## **STANDARD FIELD SERVICE BULLETIN**

FSB Number	CHRAEFSB2015-26
Author	Tony Bryan
Date	06/01/2015
Subject	XT1225 Moto Maxx, XT1254 Droid Turbo - Power-Cycle / Slow Power-Up - Damaged Sensor (Drop)
Model Affected	XT1254 Droid Turbo, XT1225 Moto Maxx
Level Of Repairs	Level 4

**Figure 1.0 - Sensor Component - Board Location (U6150 - P/N: 51016138001)**

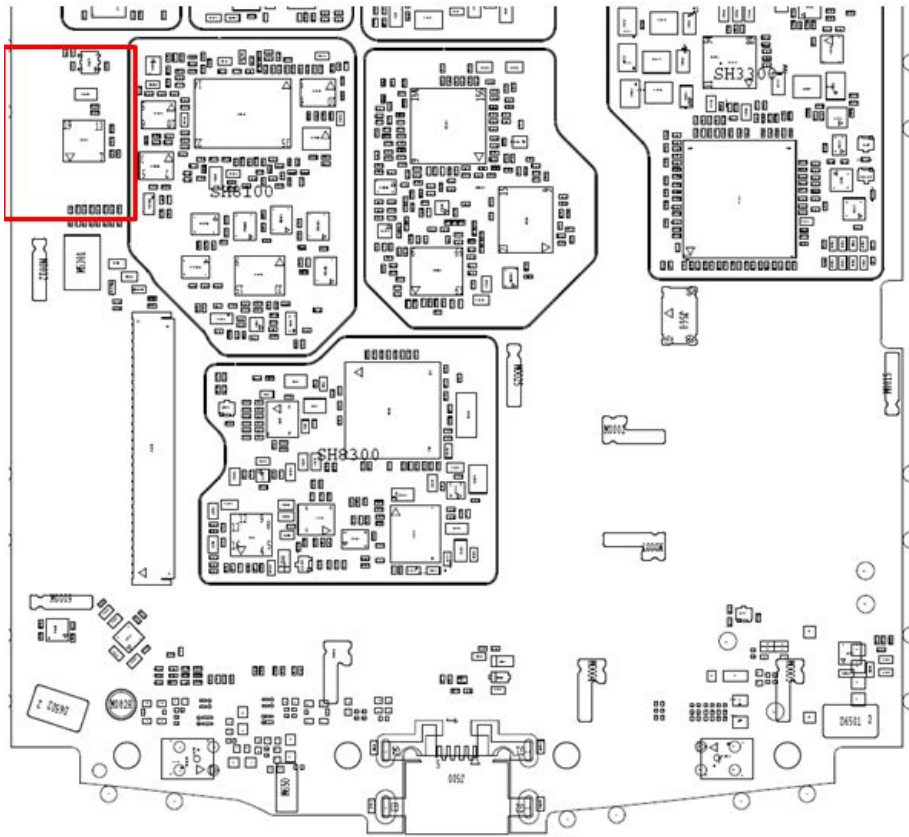
Engineering analysis of the returned devices found a damaged sensor component (U6150 - P/N: 51016138001). The sensor component was damaged by mechanical force likely resulting from a drop impact by the user. The observed symptoms can be intermittent or vary depending on the location and severity of the component damage. See Figure 1.0 below for details.

**Figure 2.0 - F-Hsg Assembly (P/N: 0101785200x) - Rev E Changes**

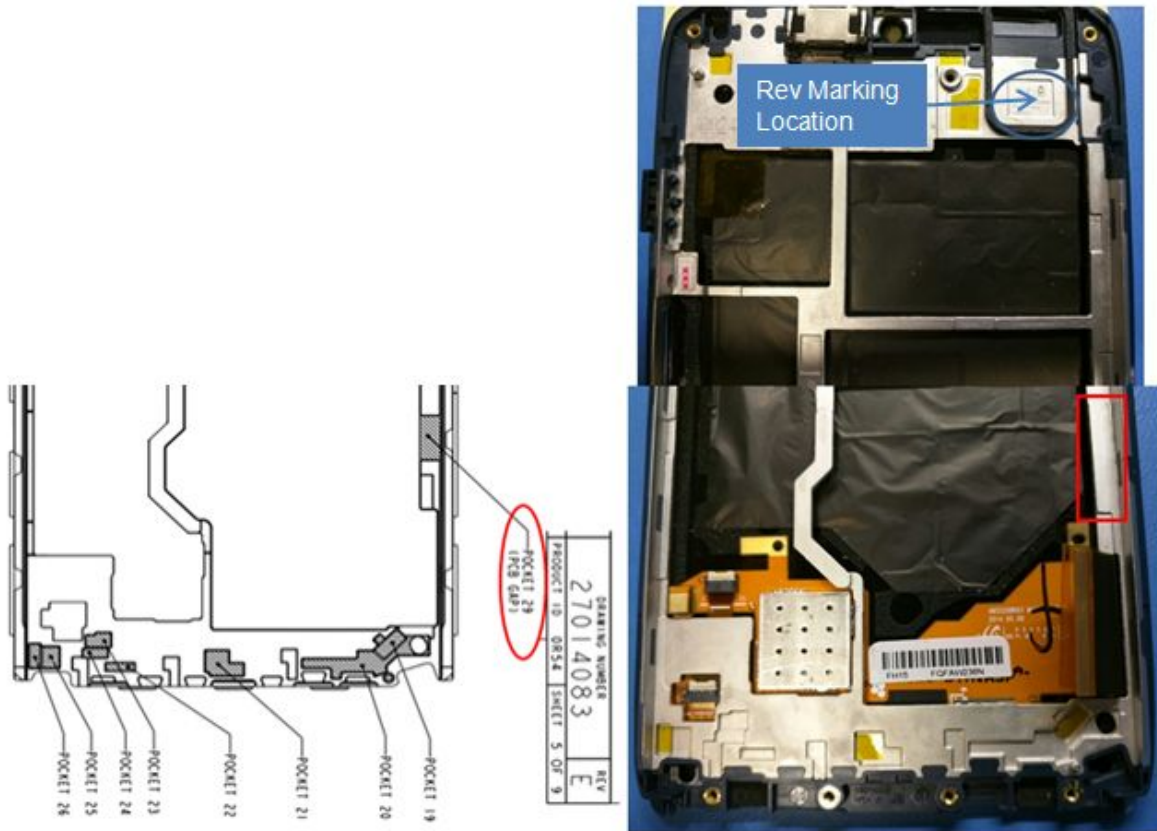
Motorola made a running change to the F-Hsg Assembly (P/N: 0101785200x) Rev. E and later to provide some additional air-space for U6150 in drop events. See Figure 2.0 below for details. Factory production cut-over to the Rev E F-Hsg Assembly starting in March 2015.

- Add sensor component (U6150 - P/N: 51016138001) to the SBOM and stock inventory of this part to support field replacement.
- Deplete existing inventory of F-Hsg Assembly (P/N: 0101785200x) and transition to Rev. E as a running change.
